# **Access Requirements for Alamitos Bay Shoreline Sorrento Trail**

City of Long Beach

September 29, 2016

## TRAIL ALIGNMENT CONCEPT PLAN

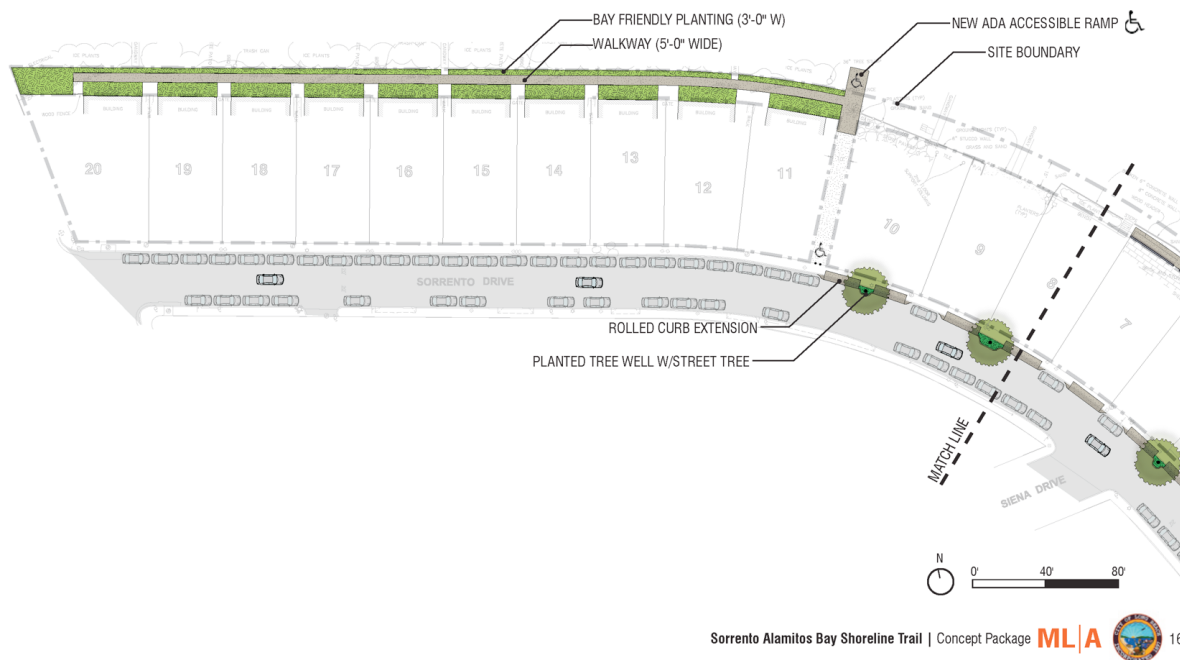
### South-Western-Most Section

In this area, from the street entry, we agree that a method is necessary to get to the water area. What we recommend is to turn the ramp so that the sloped walkway is parallel to Shoreline Trail rather than at right angles. This prevents someone using the sloped portion from going directly into the water which could be hazardous. There is over 48' from the entry to the next gangway which most likely provides sufficient space for this solution. Although not required by the ABAS or CSPAG, we recommend that this sloped walkway comply with handrails and curbs for pedestrian ramps, although the slope itself could be modified to conform with the ABAS and CSPAG trail slopes. Turning/passing spaces on the sloped area should be provided at various points to accommodate rise in the waterway.

The western-most area which is currently being used as a small boat launch. If no work is being done to the area and there is another small boat launch that is accessible in the vicinity then this would not need to be made accessible per *program accommodation*, if it is indeed equivalent. We recommend that if there is no other small boat launch, then this area should become an accessible boat launch. If this is not the intent for this area, then signs should be posted prohibiting the area from being used as a boat launch.

### TRAIL ALIGNMENT CONCEPT PLAN

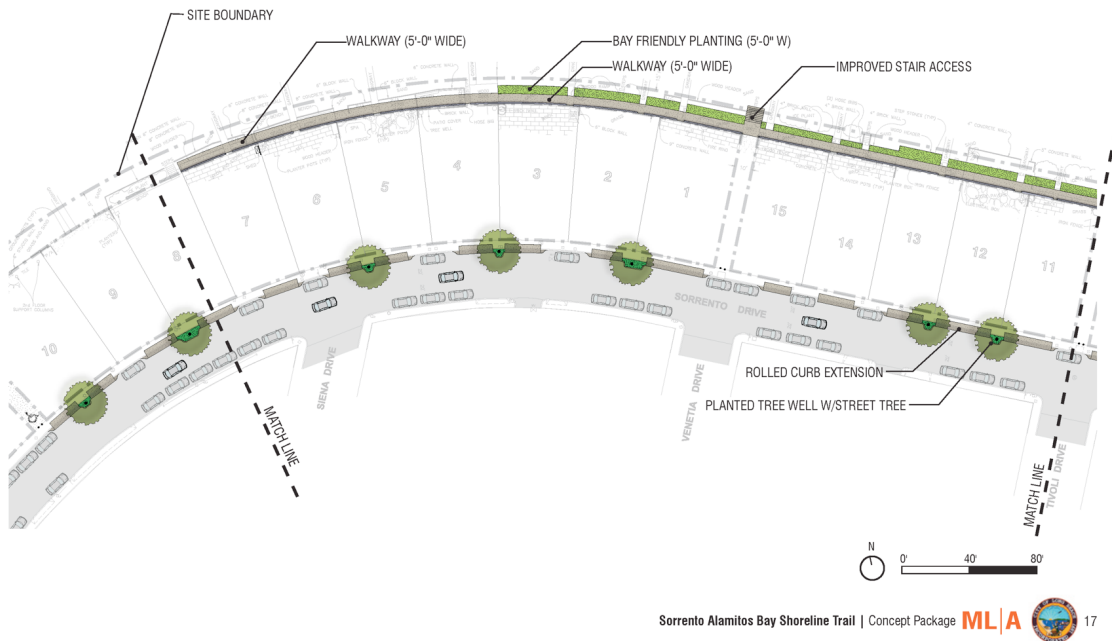
### West of Venetia Drive

The proposed 'improved' stairs at the end of Venetia Drive has a substantial height differential. In our opinion, this makes access in this area down to the water's edge technically infeasible per the ADAS definition of site constraints and due to the location of adjacent gangways. It is our understanding that the three lots located adjacent to the walk west of Siena Drive do not require being developed per the Coastal Development Permit Item #14C since the stipulation is to avoid new fill and boardwalk. What we recommend as equivalent facilitation to the Venetia Drive stairs is to ramp the walkway down starting at the edge of the gangway in front of Lot 7. The space between the gangways at lot 7 and lot 9 is roughly 95 linear feet per the Tract Map. This would provide enough space to gradually slope down an accessible trail to the sand and water's edge. Consideration should be given to the recommended elements of turning spaces, handrail, and curb as previously delineated under the South-Western-Most section.

If it is determined that there will be no improvement west of Venetia Drive due to soil conditions thereby extending the unimproved area, we recommend providing a viewing area adjacent to the stairs at the end of Venetia Drive.

### TRAIL ALIGNMENT CONCEPT PLAN

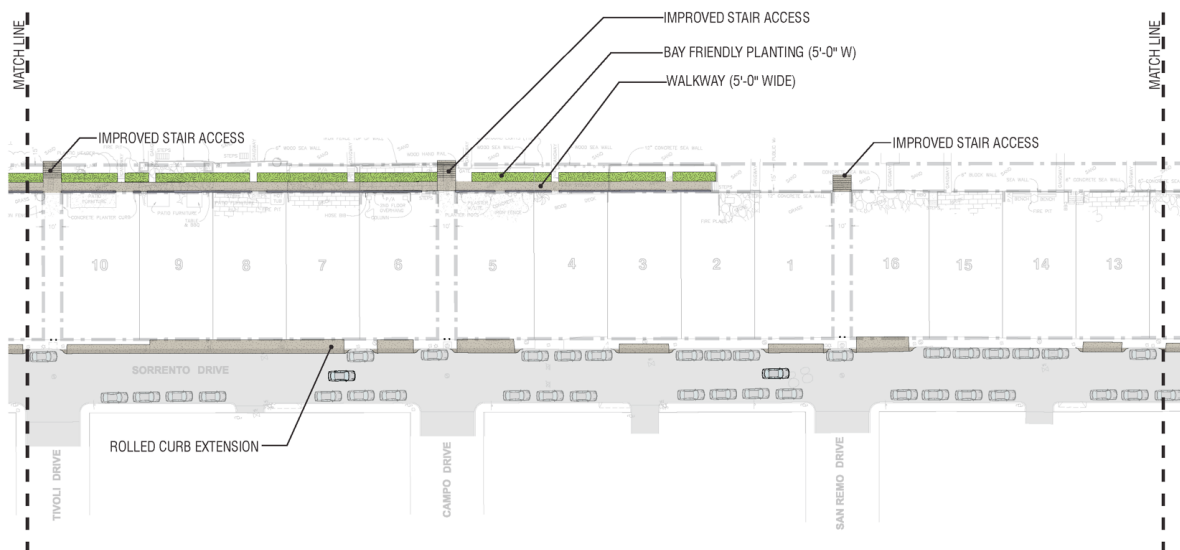
### From Tivoli Drive to San Remo Drive

The proposed 'improved' stairs at the end of the vertical accessways located at the end of the three drives also have a substantial height differential. In our opinion, due to this and adjacent gangways, access to the water/sand in this area would be technically infeasible per the ADAS definition of site constraints. A necessary measure, in order to provide an equivalent experience, other than installing wheelchair lifts, which may have its own set of challenges, is to provide viewing areas at the head of the stairs. Even though the existing stair run in front of lot 2 is not being improved, we recommend also placing a viewing area to afford those who can not negotiate steps some measure of comparable experience.

At the Tivoli Drive stairs it would be preferable to have a viewing area on each side, whereas at the Campo Drive stairs one viewing area is preferable to the west due to adjacency of gangways. In front of Lot 2, there appears to be enough space to slightly ramp down to a viewing area to the west of the stairs bringing people closer to the water and would be recommended, even if it is only 6". We also recommend that the proposed 'improved' stairs at the end of San Remo Drive have the stairs running at right angles towards the west from the vertical accessway, rather than in the same direction, with a viewing area straight ahead or towards the east.

## TRAIL ALIGNMENT CONCEPT PLAN

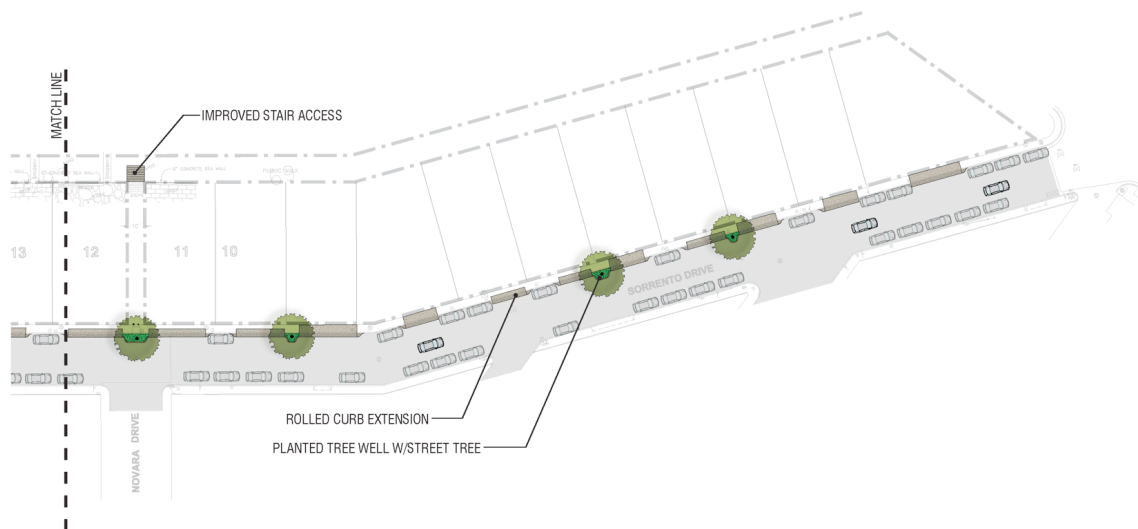
## Novara Drive

The proposed 'improved' stairs at the end of Novara Drive also has a substantial height differential and in our opinion would make access to the water/sand technically infeasible. Regardless, some measure of equivalent experience would need to be provided.

We recommend that the proposed 'improved' stairs at the end of San Remo Drive also has a viewing area at the top of the stairs looking east.
